ED-HMI3010-133C

PCN

Product Change Notice 1

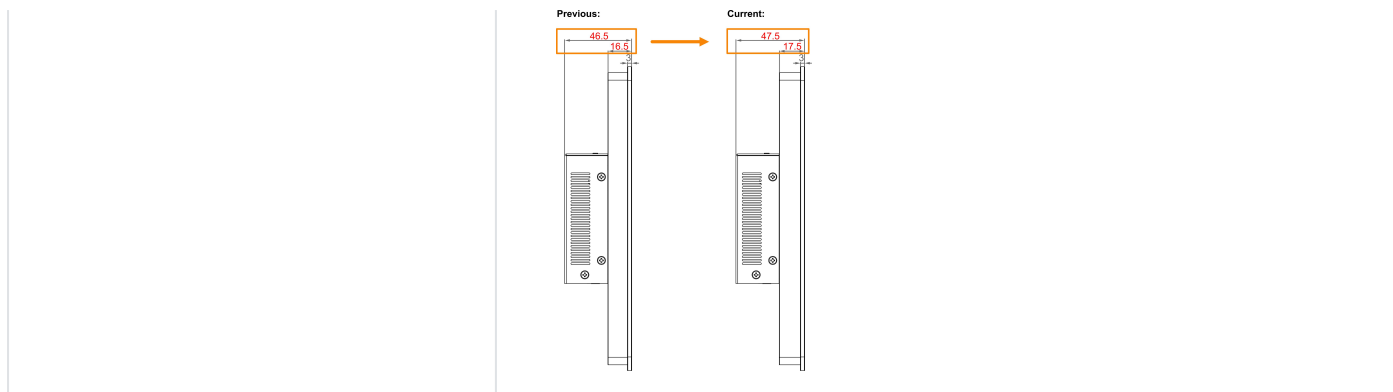
Changes	Results
LCD bezel thickness increased by 1mm	We have optimized the LCD bezel structure to provide additional clearance for internal cable routing. - LCD bezel thickness: adjusted from 16.5mm to 17.5mm. - Total product thickness: correspondingly adjusted from 46.5mm to 47.5mm.
